Subject: Invitation for Bid #14-1713-OV, Southwest Water
Reclamation Facility (SWWRF) Rehabilitation Main
Plant and Belt Filter Press Drain Station / Project Nos:
Main Plant: 5128184 and Belt Filter Press Drain Station:
5128183

ADDENDUM #1

Performance Curve

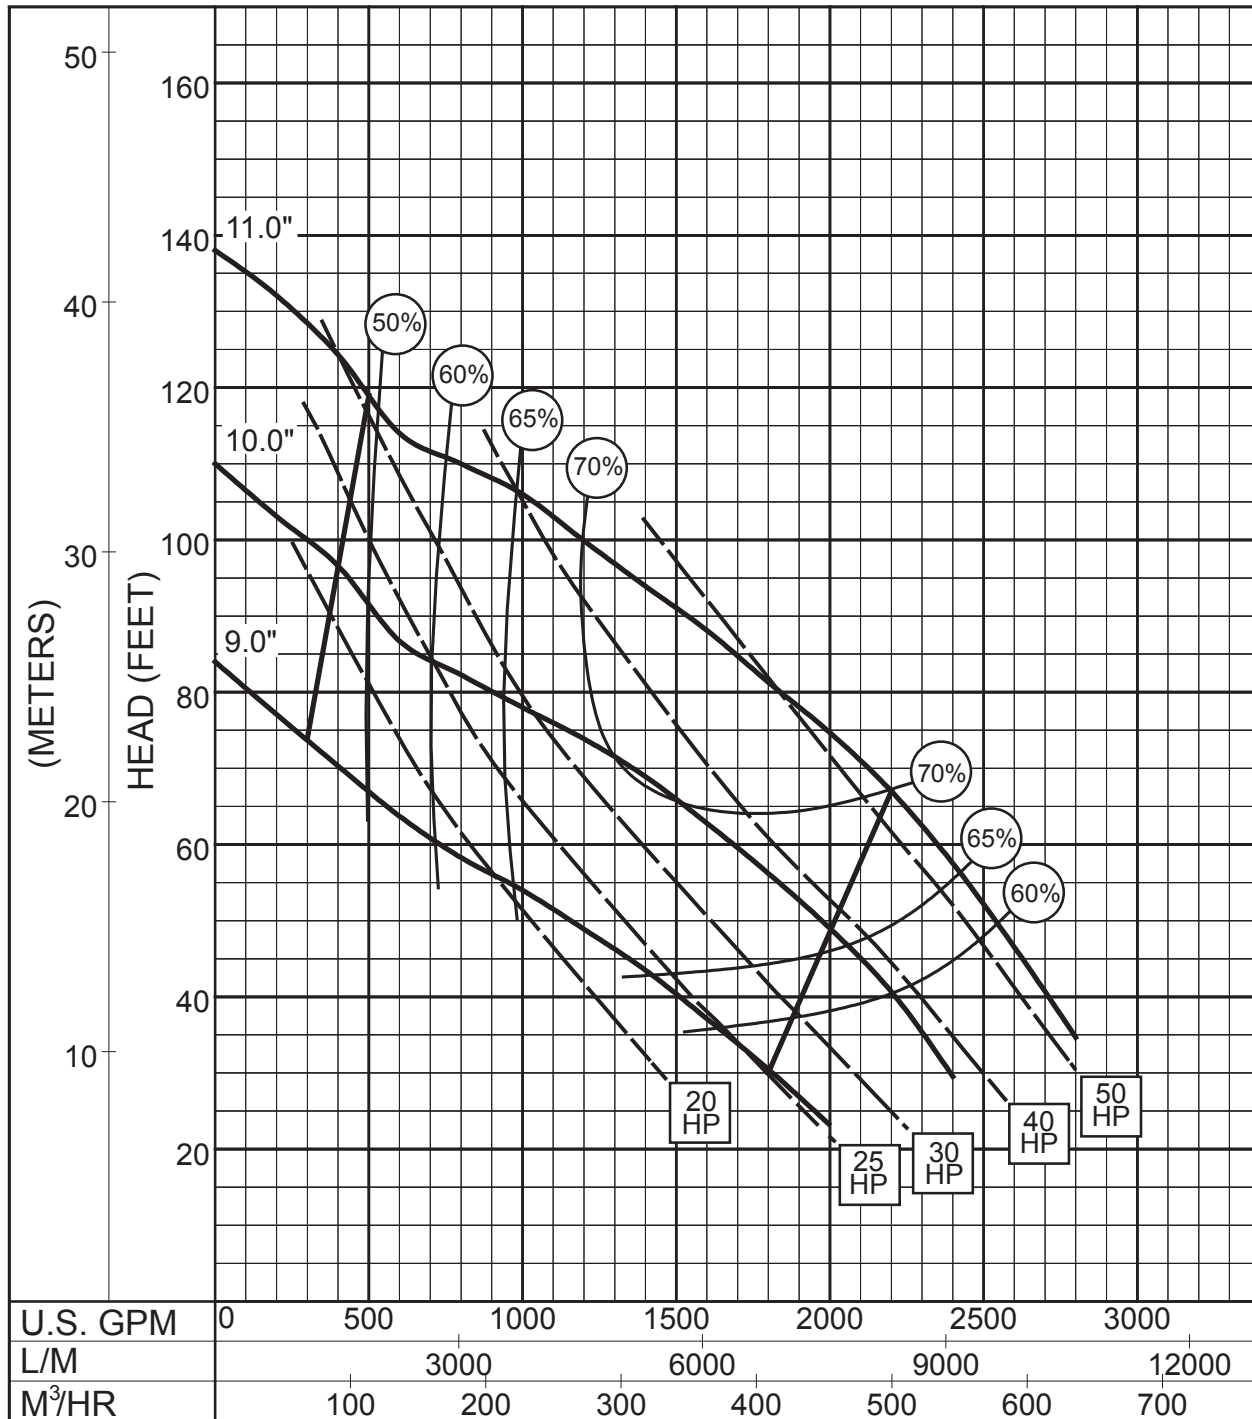
Q1. There is no reference to duty points for the individual stations. GPM and TDH would be required to properly size the temporary bypass system. Existing electric submersible curves could be supplied as reference.

R1. See attached performance curve and flow data. The Headworks 12" ductile is piped to approximately 20 feet high.
